Flood Damage Reduction Segment / System Inspection Report

Name of Segment / System: Little Cal - Munster

Date Report Prepared: 5/22/2014

Flood Damage Reduction Segment / System
Inspection Report
Little Cal - Munster (LCMN)

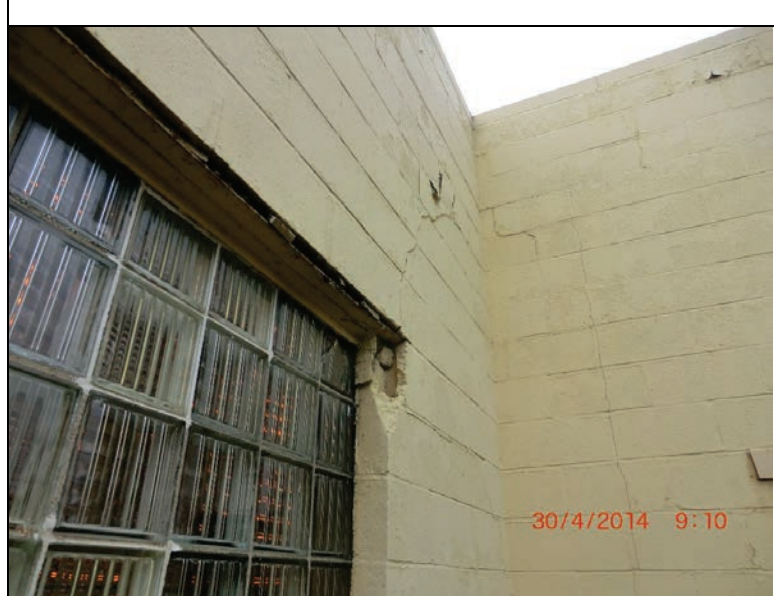
<p>Inspect ID: LCMN_2014_a_0087 Title: USACE_CELRC_LCMN_2014_a_0087_1.jpg Rated Item: 5. Plant Building Caption: Rating: Minimally Acceptable; Remarks: PS-CAL: Exposed rebar; Action: Patch concrete</p>
	<p>Inspect ID: LCMN_2014_a_0088 Title: USACE_CELRC_LCMN_2014_a_0088_1.jpg Rated Item: 5. Plant Building Caption: Rating: Minimally Acceptable; Remarks: PS-CAL: Spalling in foundation slab; Action: Patch</p>
